No: 25-004

DAUPHIN COUNTY SUBDIVISION/LAND DEVELOPMENT REVIEW REPORT

Plat TitleProposed McDonald’s Restaurant

Project Description: The project proposes to amend a previously approved land development application to replace the previously proposed QSR restaurant with a McDonald’s restaurant including associated site improvements.

SITE PLAN

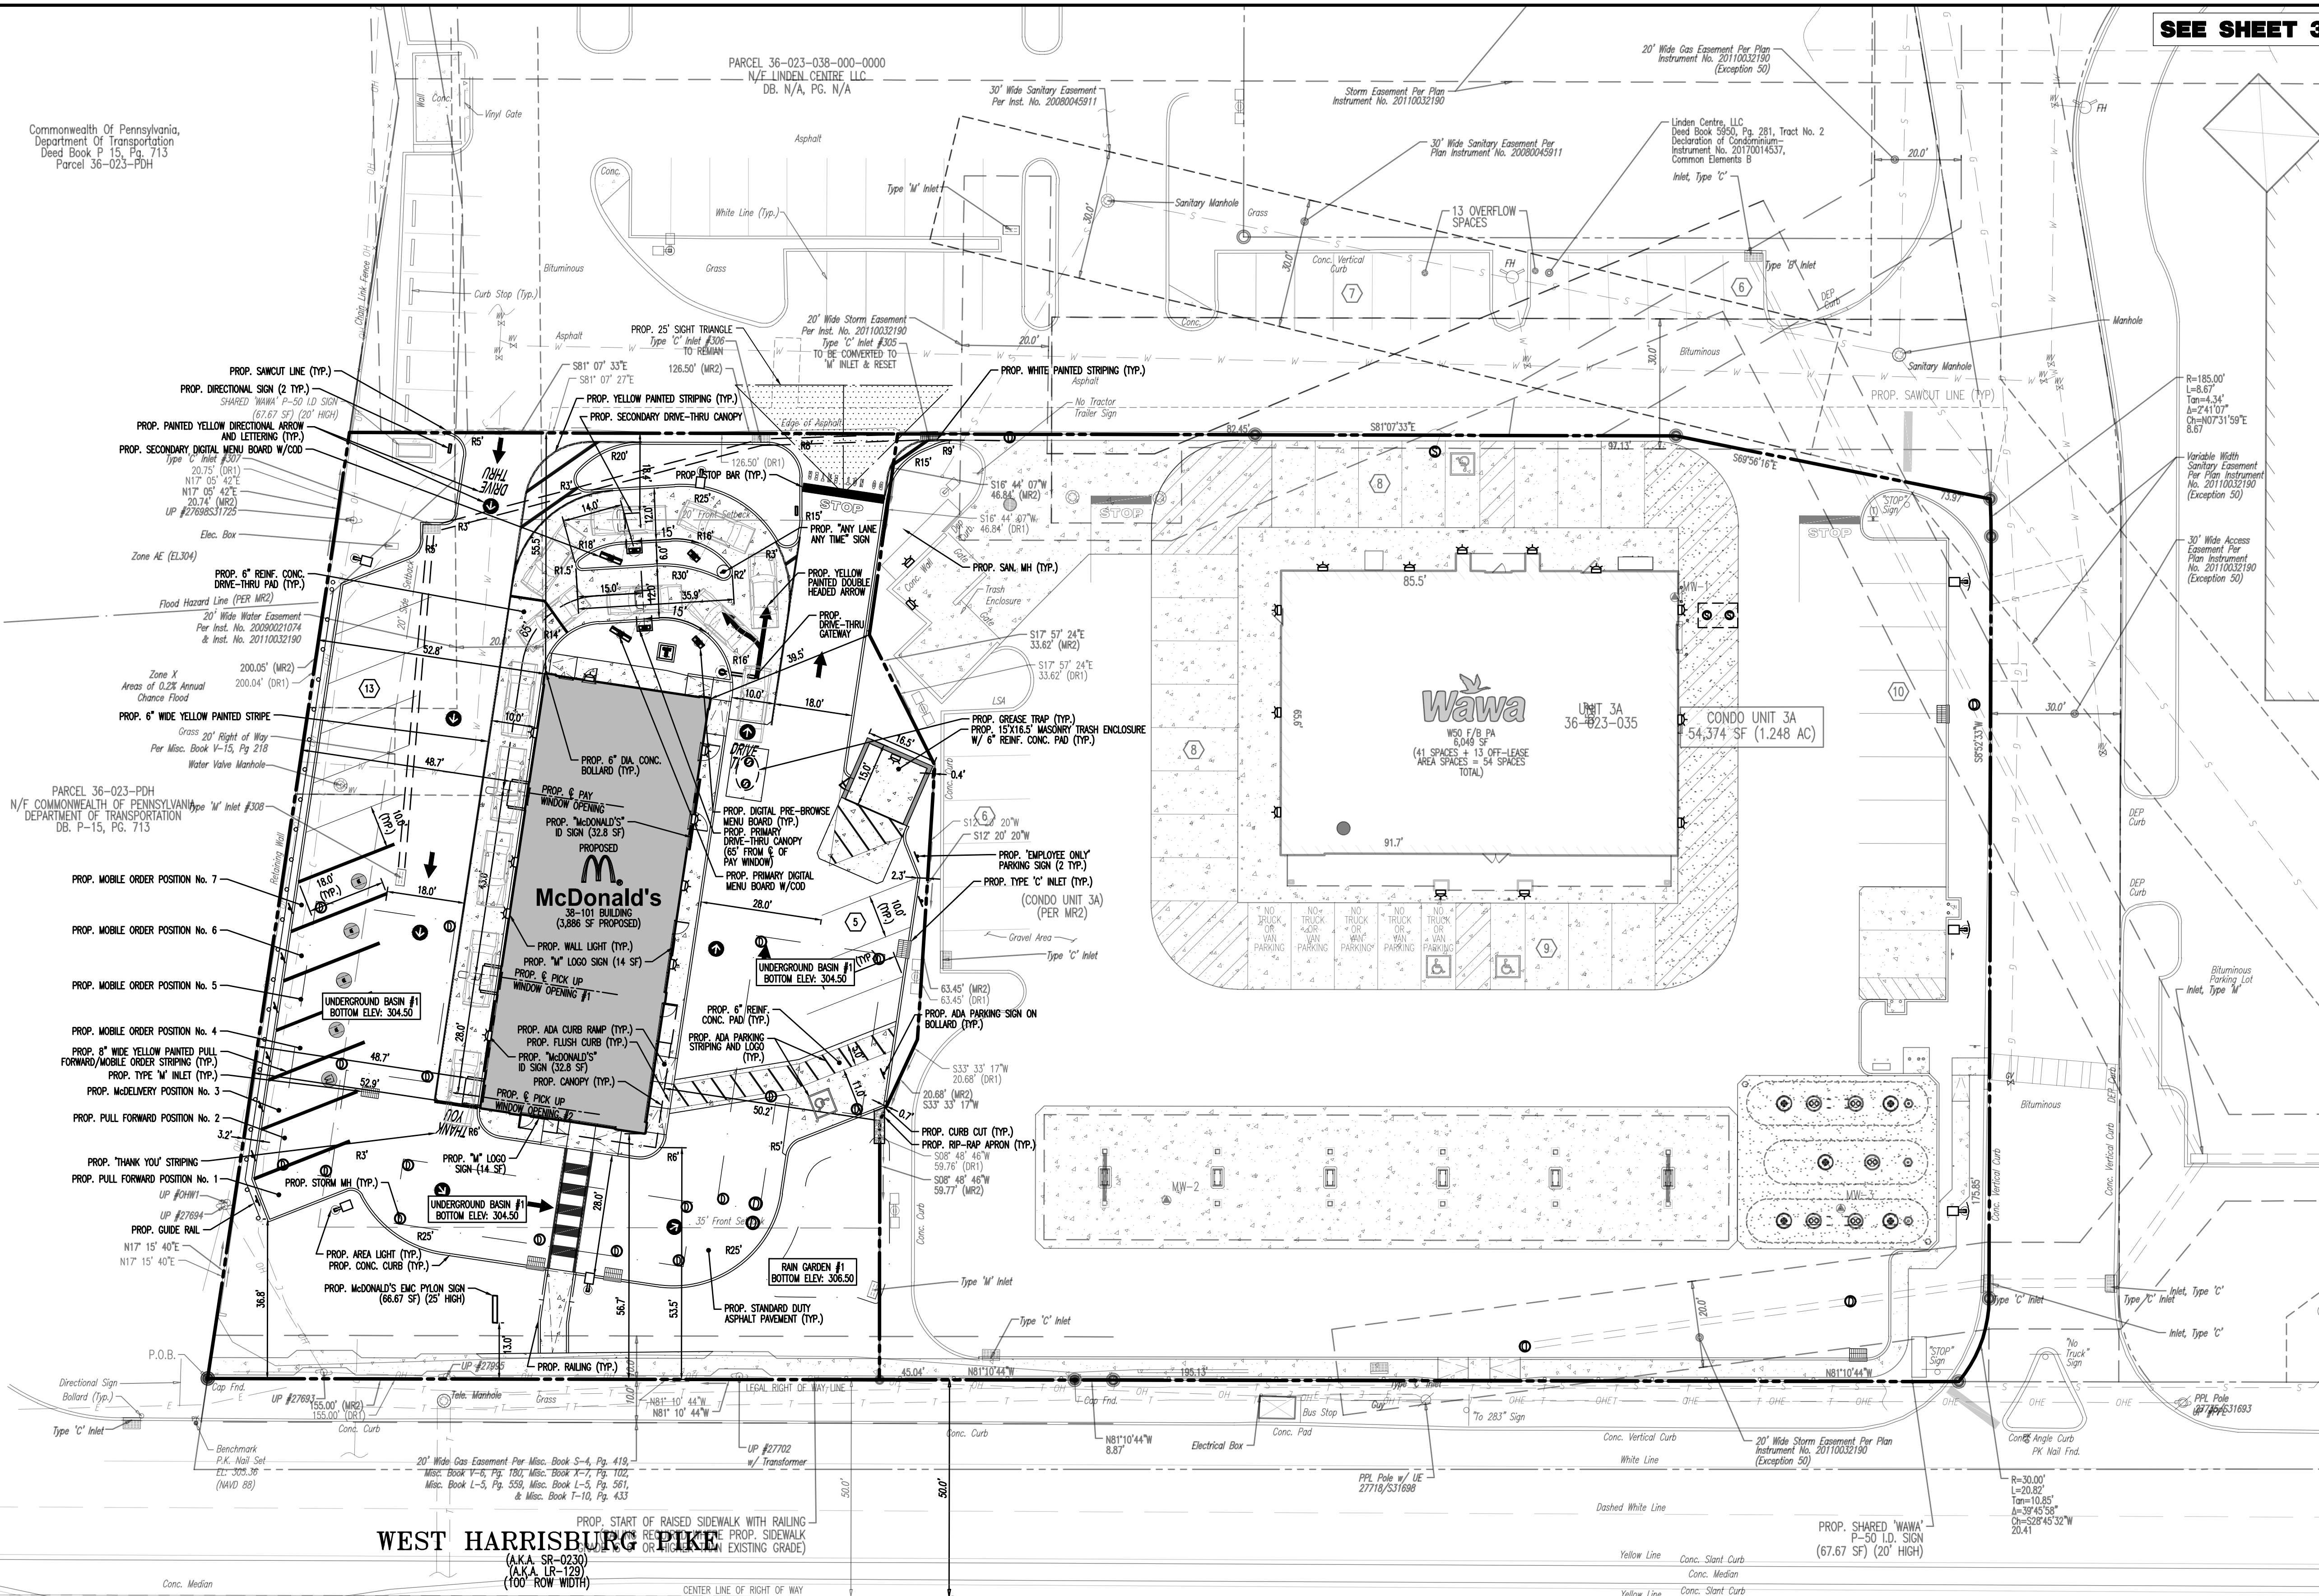
- Is there any potential conflict between vehicles leaving the site from the parking area versus those leaving the drive-through?
- The parking calculations include both the proposed restaurant and the existing WaWa. Exactly how many new spaces are being added? Which development are they meant to serve?
- County data shows significant floodplain presence on the site. Does the location have any known flooding or existing stormwater/runoff issues that may need special consideration?
